of Plan Change 93 to the Bay of Plenty District
Plan (Te Puna Springs Estate Limited)

**STATEMENT OF REBUTTAL EVIDENCE OF AARON COLLIER
FOR TE PUNA SPRINGS ESTATE LIMITED
5 JULY 2022**

Figure 1 General Stormwater Layout.

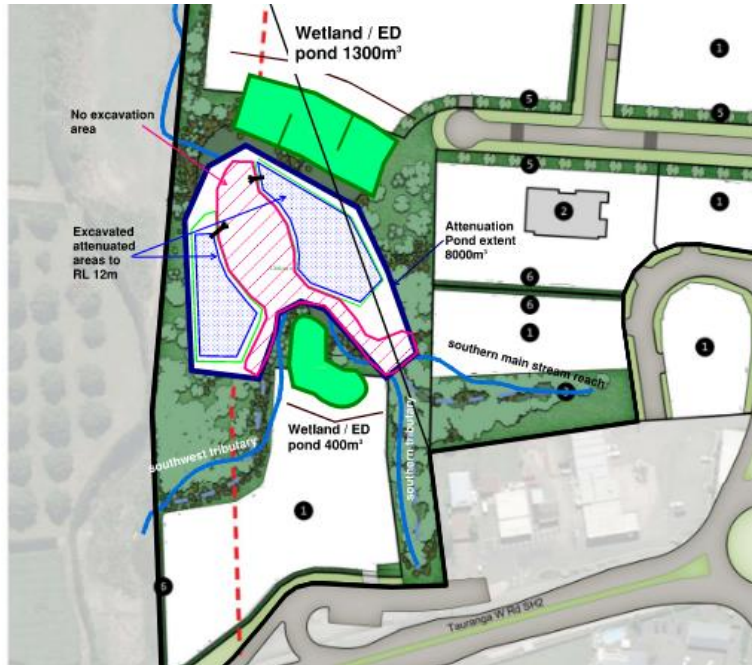
- 5.1 To address the relevant concerns raised by BOPRC, I recommend adding the following suggested changes to the proposed plan provisions. These would follow on from those set out in 5.12 of my evidence (riparian margins) with a new structure plan standard to deal with stormwater management as follows:

- ii) Stormwater detention tanks in park and carparking/roading areas for stormwater attenuation.

Stormwater management for the site shall occur in general accordance with Figures 1 and 2 (below).

- 5.2 The above provisions will provide for alternative stormwater approaches to be utilised on the site whilst not undermining or predetermining any pending discharge consent application to be assessed and processed by the Regional Council.

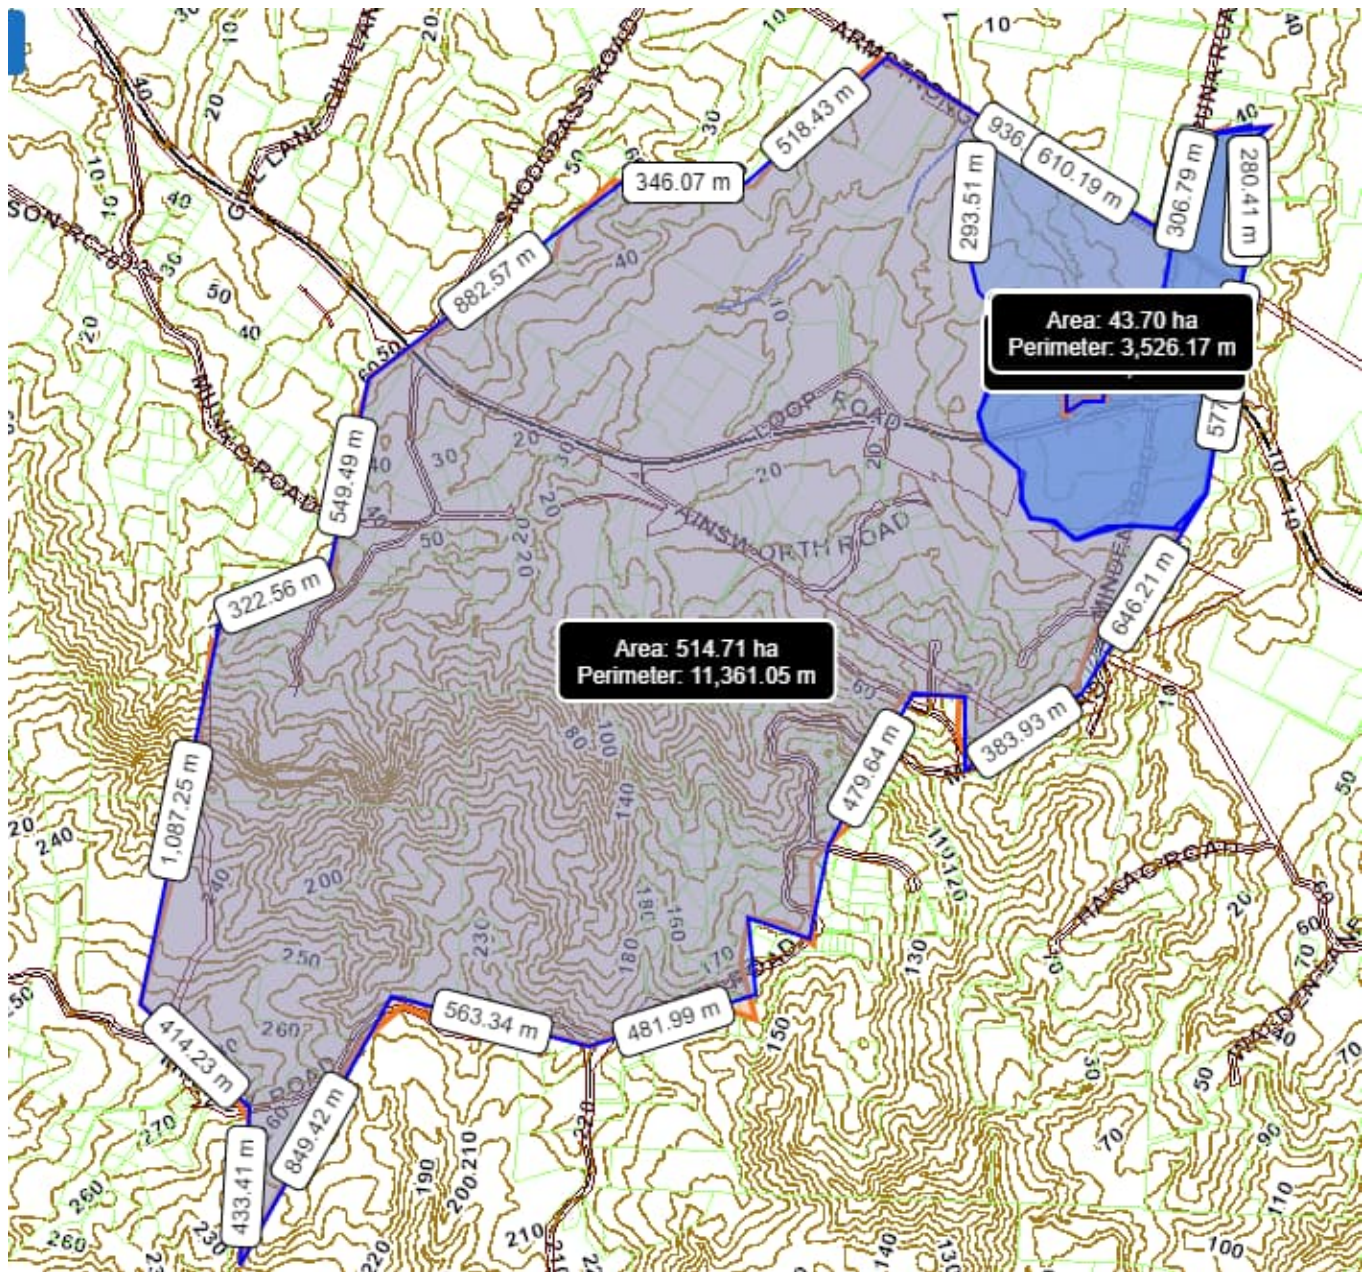
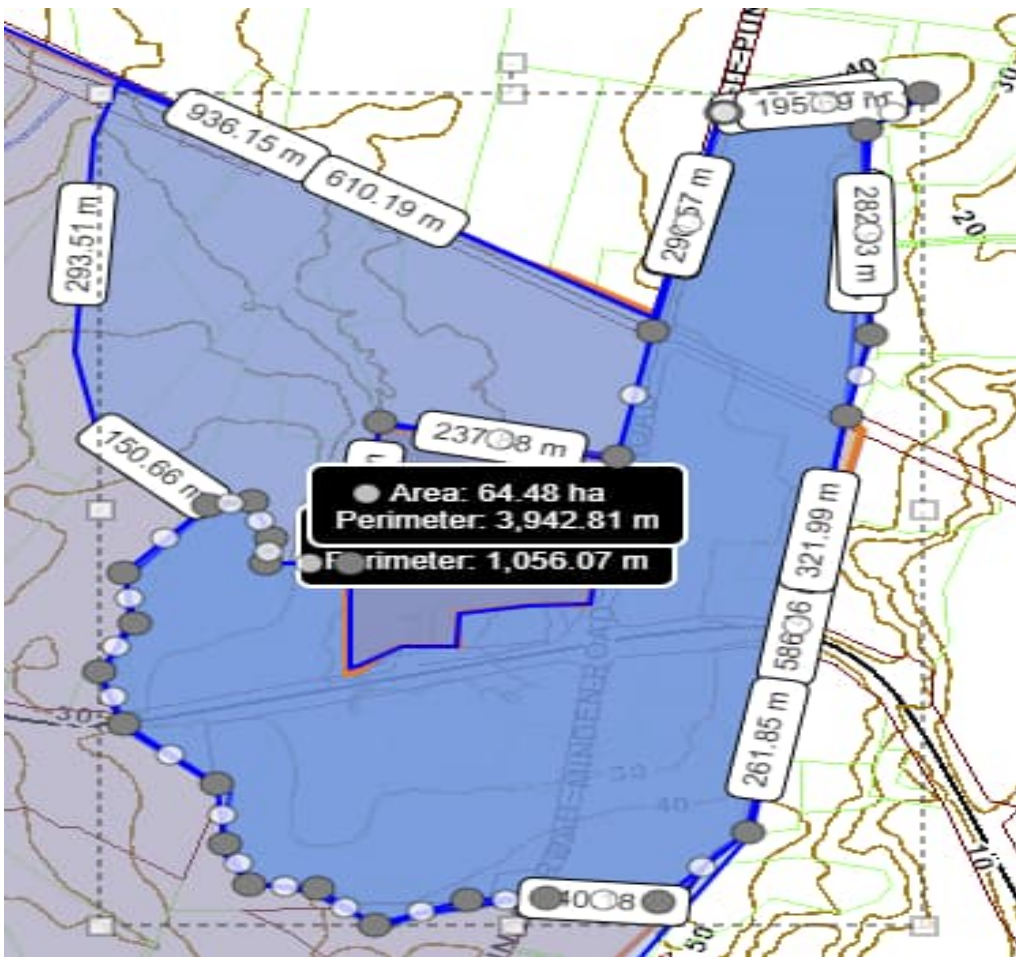
In terms of catchment wide considerations, the context of the proposed development within the wider catchment of the next downstream piece of significant infrastructure (the Armstrong Road Culvert) the relative catchments and their contributions to this road culvert are summarised as follows:

By way of visual comparison of the catchment area with topographical information, there is a large proportion of the catchment to Armstrong Road that is of greater distance away and therefore likely to be delayed in terms of the peak discharge arriving at the road culvert. As there is some attenuation within these catchments from road crossings, low lying flood plain areas, etc, a catchment wide analysis may support a reduced level of attenuation on the site to reduce the delay in peak discharge associated with attenuation (so that it does not arrive at the downstream infrastructure at the same time as the balance of the larger catchment). The existing pond however already delays the peak by approximately 20min so the peaks currently would be almost aligned.

As the site forms only 1.2% of the overall catchment at Armstrong Road, and the increase in runoff from the plan change area would be less than 1% of the flow at Armstrong Road, the sensitivity is minimal in terms of the overall catchment, but would be improved by the sizing of the infrastructure on site to achieve the necessary levels of attenuation.

In summary, the flood management has been analysed and described in the Plan Change application to show that attenuation and treatment can be achieved with no on site attenuation or treatment within the commercial sites themselves. The option to incorporate further measure “on site” has also been offered as set out in my email dated 17 June.
